ADDENDUM NO. 2

PACIFIC HIGH SCHOOL – NEW ADMINISTRATION BUILDING

SAN BERNARDINO CITY UNIFIED SCHOOL DISTRICT

DSA No. 04-119637 File No. 36-H7 RCA Job No. 1-78-28

BACS RISER DIAGRAM

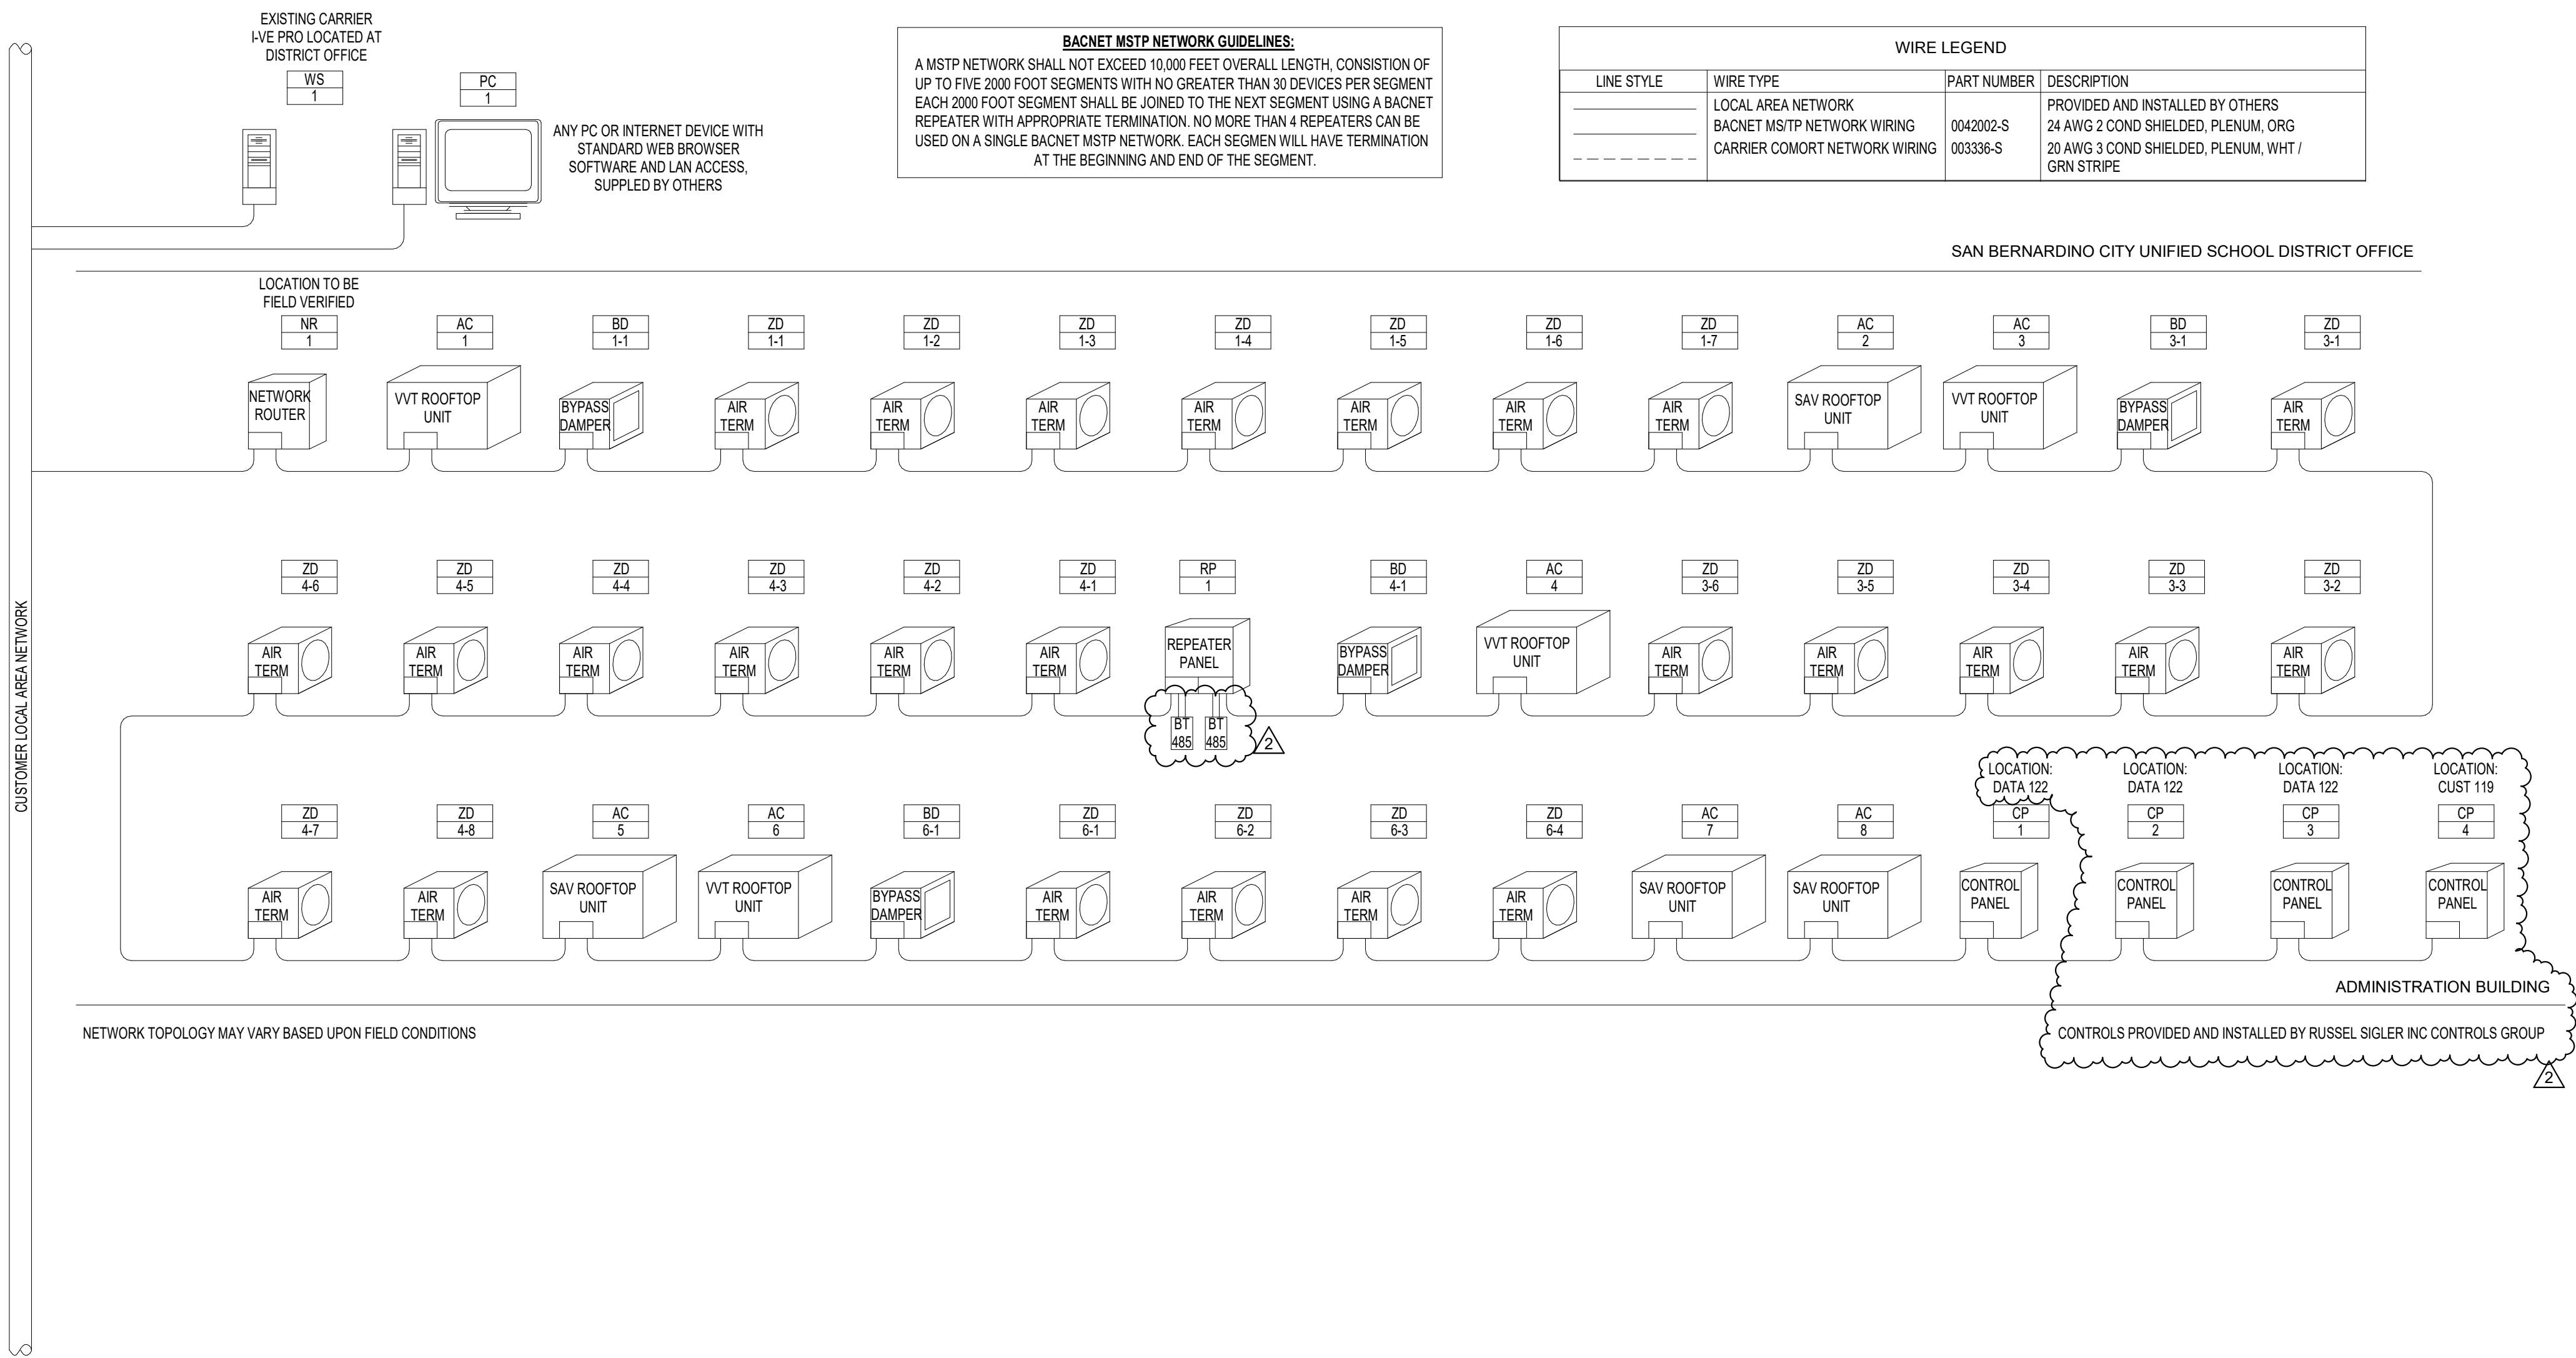
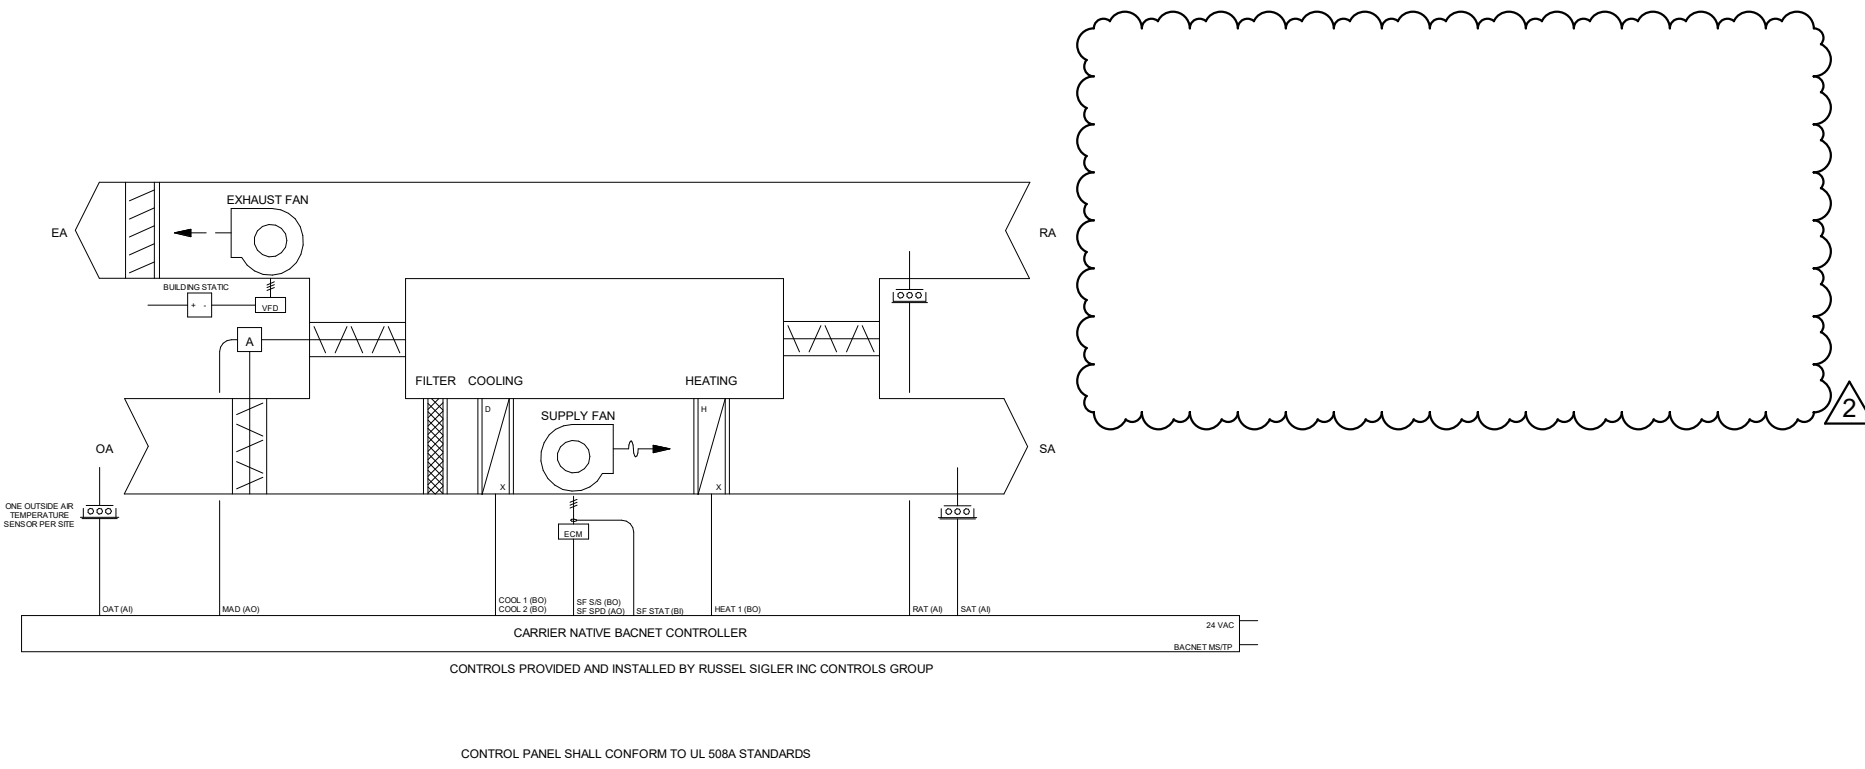
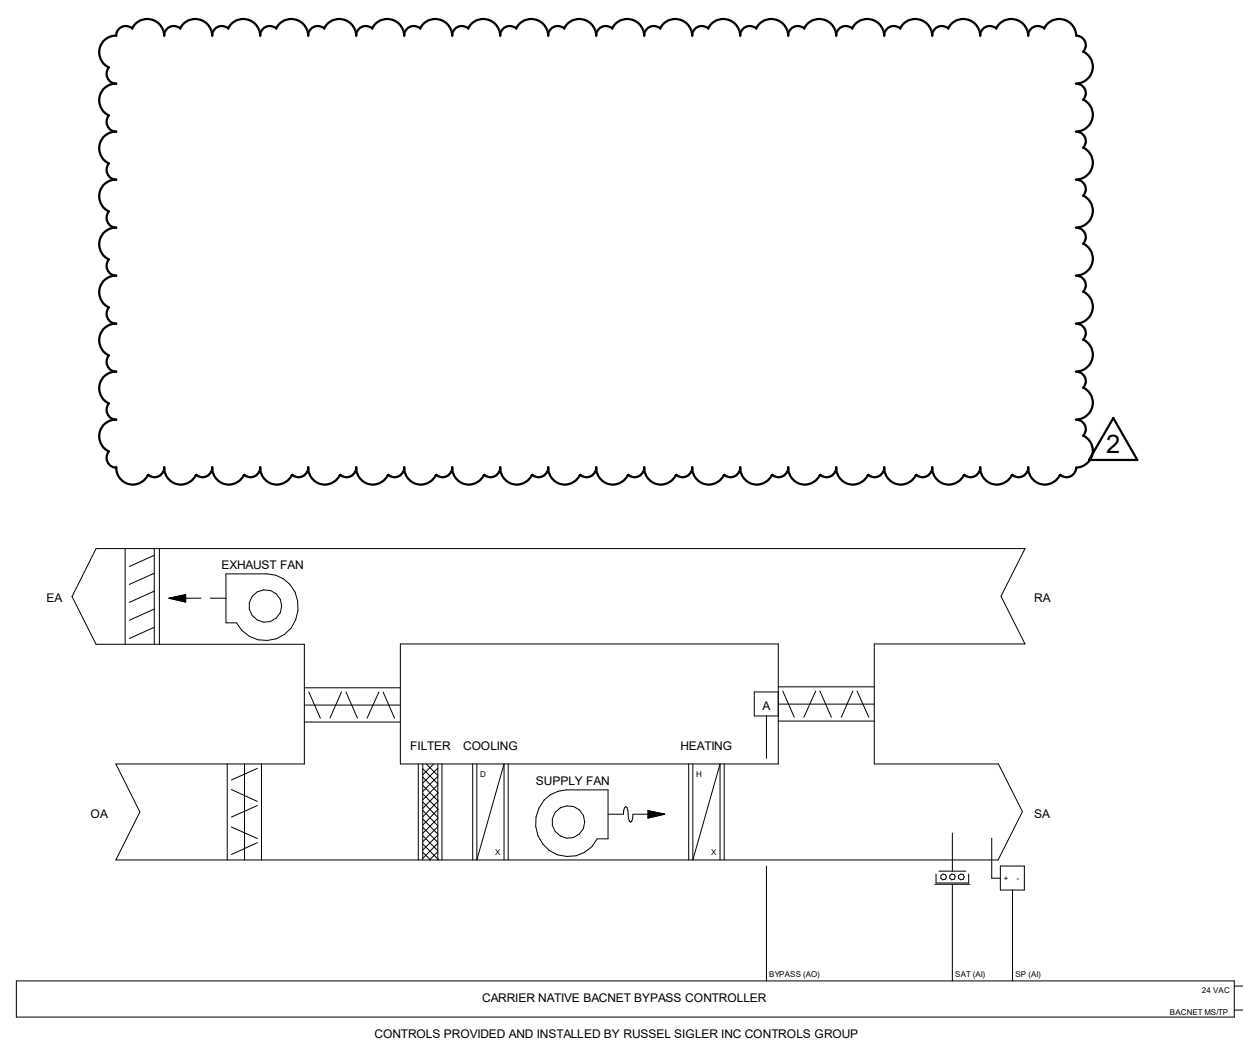
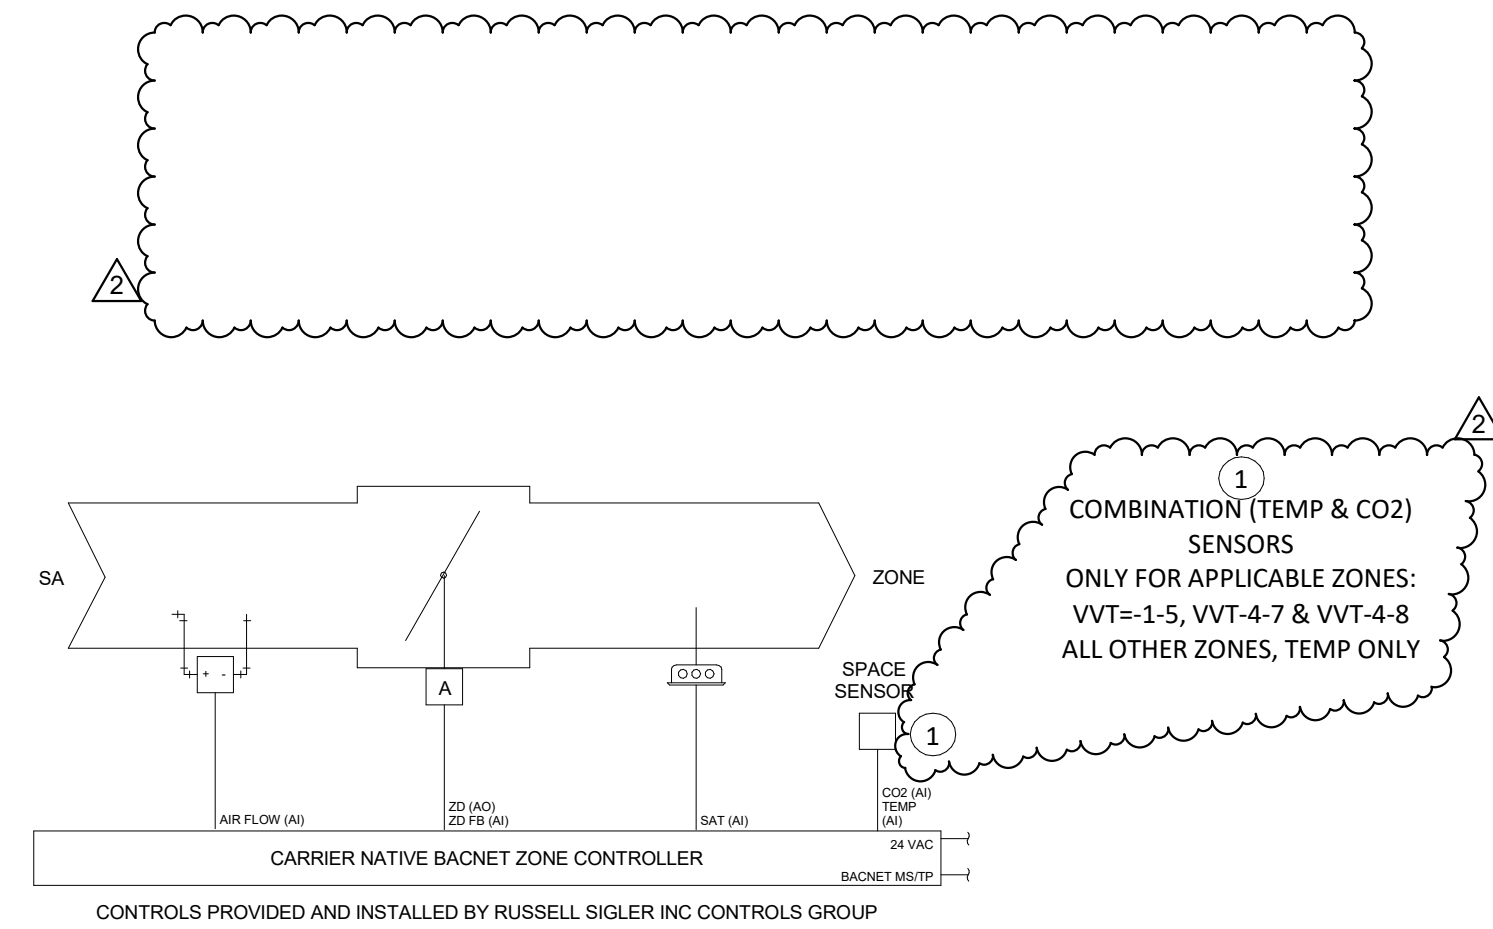
- Item No. 2.16 Reference Sheet MD-3.1:
2.16.1 Revise EMS per clouded areas of attached revised Sheet MD-3.1:
 a. Revised EMS BACS riser diagram to include the 3 additional control panels and revised their actual location.

b. Revised VVT zone damper EMS detail to include note for when a temperature/CO2 sensor is required.
 c. Included sequences of operations for zone dampers that include CO2.

d. Included sequences of operations for VVT rooftop occupied mode. Revised set points to District's standards
 e. Removed set points tables as they are shown within the diagrams.

EXHAUST FAN, CIRCULATING PUMP & EXTERIOR LIGHTING CP DETAIL

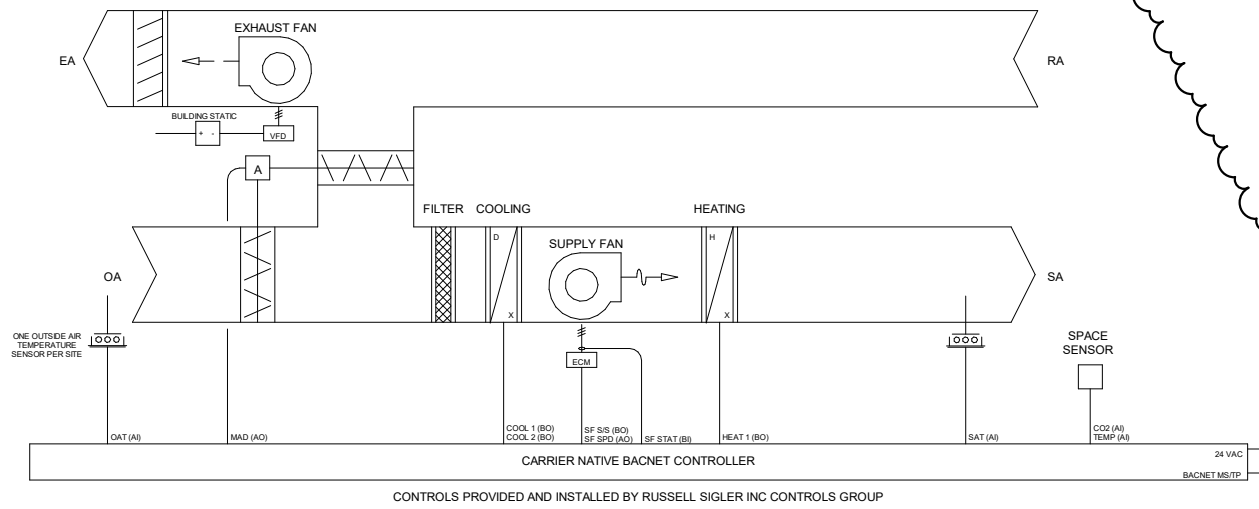
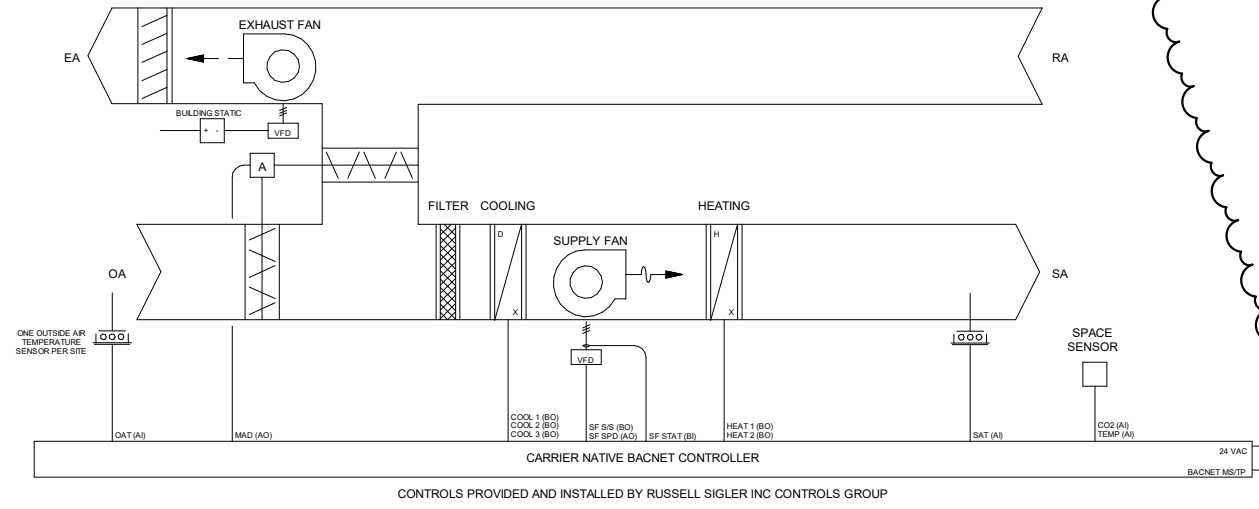
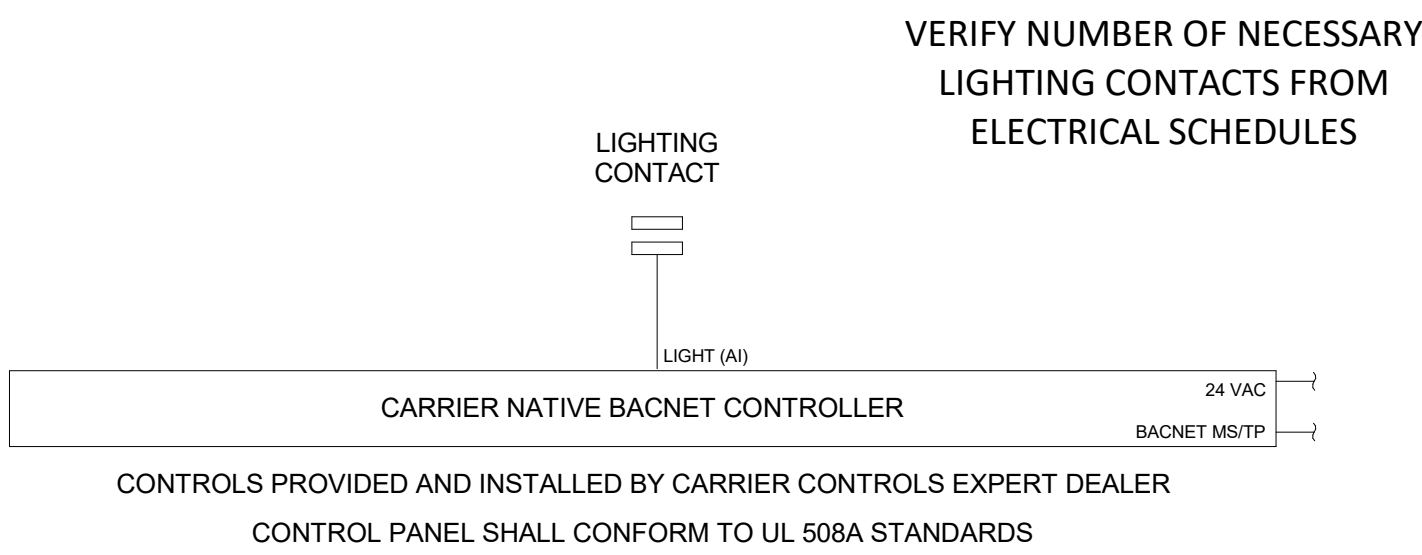
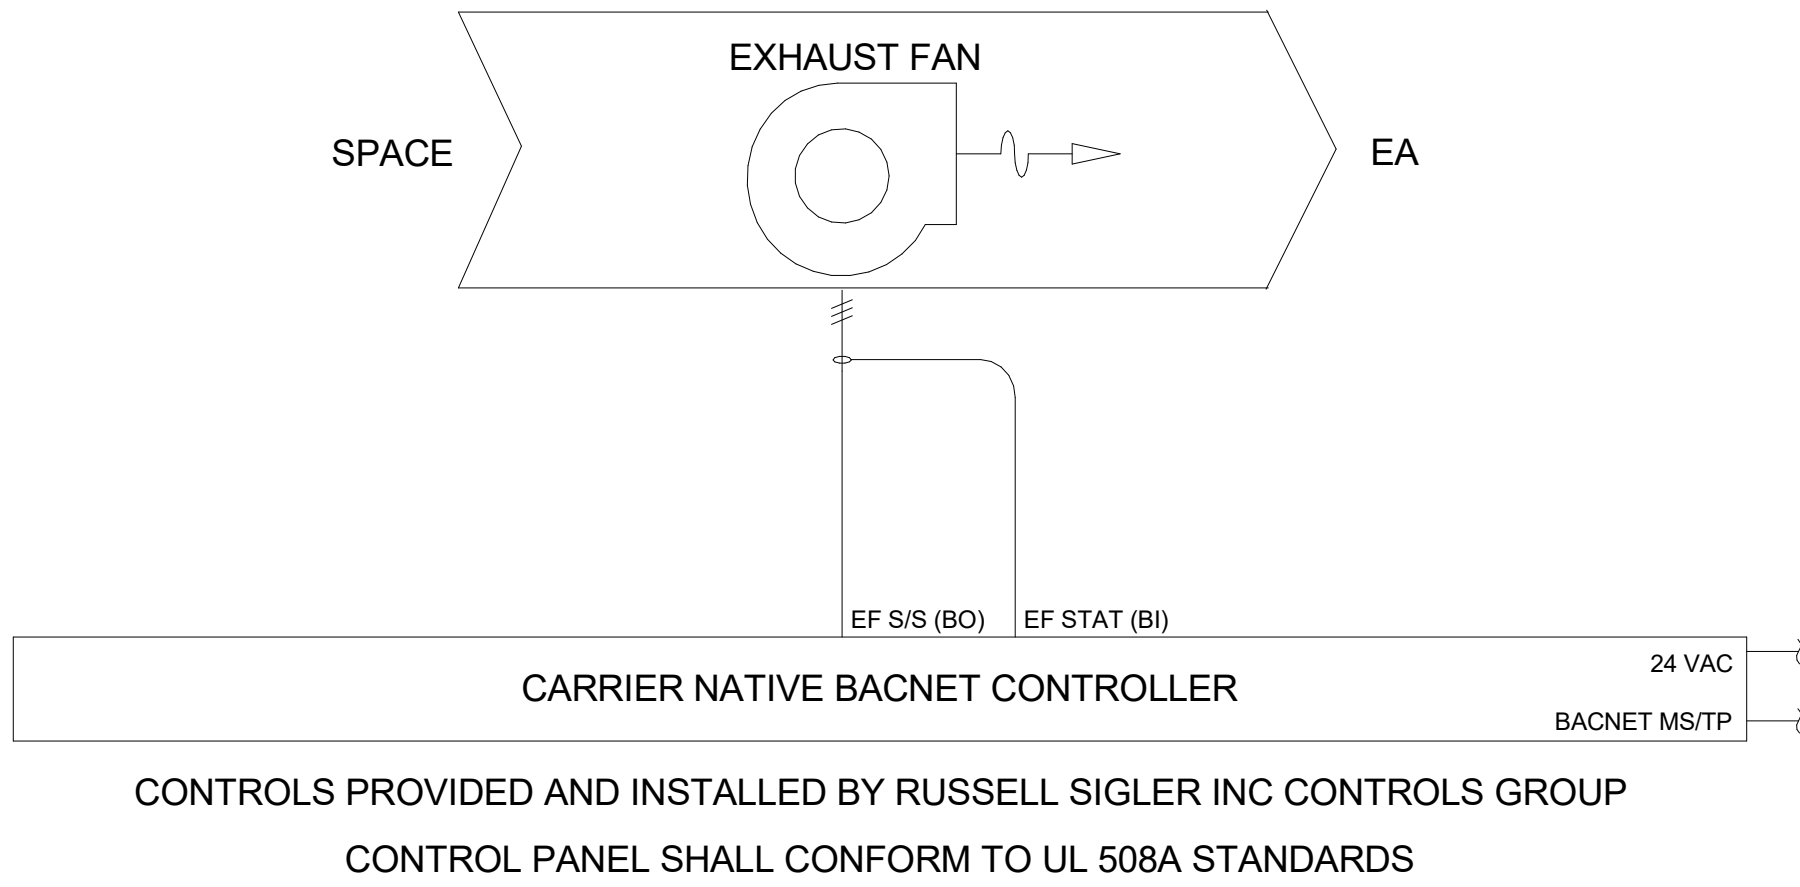
- Item No. 2.17 Reference Sheet MD-3.2:
2.17.1 Revise EMS per clouded areas of attached revised Sheet MD-3.2:
 a. Included sequences of operations for 3-cool/2-heat stage rooftop occupied mode. Revised set points to District's standards

b. Included sequences of operations for 2-cool/1-heat stage rooftop occupied mode. Revised set points to District's standards
 c. Removed set points tables as they are shown within the diagrams.

d. Removed CO2 portion of sequences of operations for both units since it does not apply.
 e. Added circulating pump and exterior lighting controls details. Revised exhaust fan control detail.
